SUBJECT: **Heated Steering Wheel Performance Upgrade 22G06 – Supplement #1**
Certain 2023 Model Year F-150 Vehicles
Heated Steering Wheel Performance Upgrade

REF: **Heated Steering Wheel Performance Upgrade 22G06**
Dated: September 14, 2023

New! REASON FOR THIS SUPPLEMENT

CERTAIN 2023 MODEL YEAR F-150 AND F-150 LIGHTNING VEHICLES — HEATED STEERING WHEEL ACTIVATION

FIGURE 9

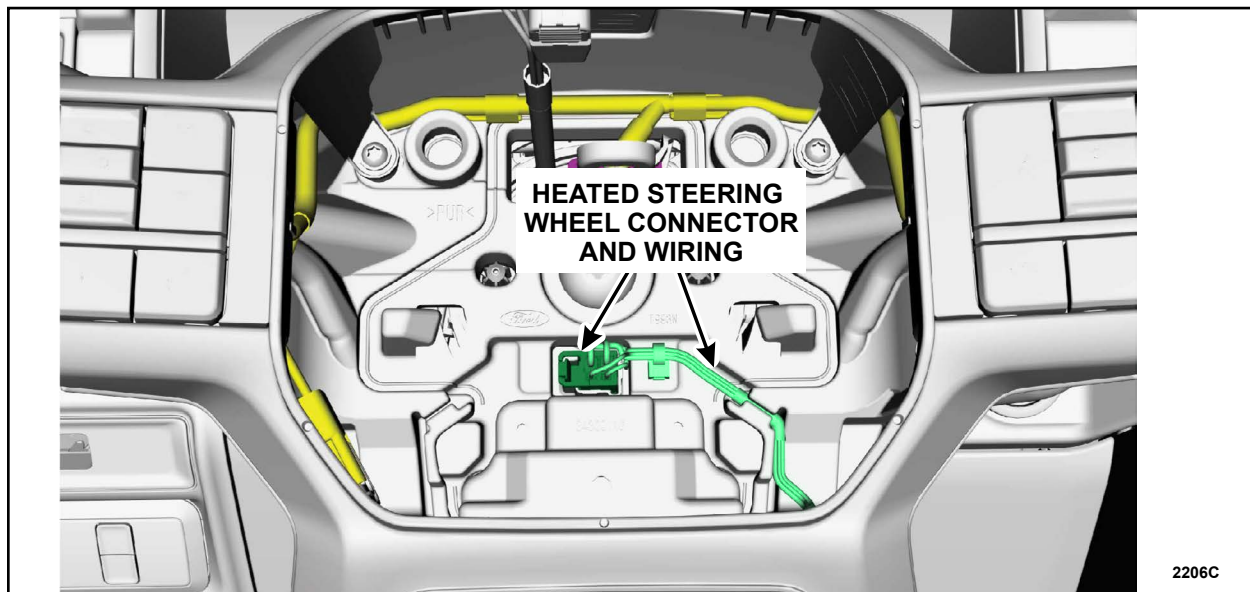
3. Does the vehicle have a heated steering wheel connector and wiring as shown highlighted in green in Figure 9?

Yes - Proceed to Step 4.

No - Order a new steering wheel using Figure 10 and the corresponding part number in the dealer bulletin and Proceed to Step 5.

9. Install new SCCM, *and a new steering wheel if the vehicle was not equipped with heated steering wheel connector and wiring.* Reverse Steps 1-8.
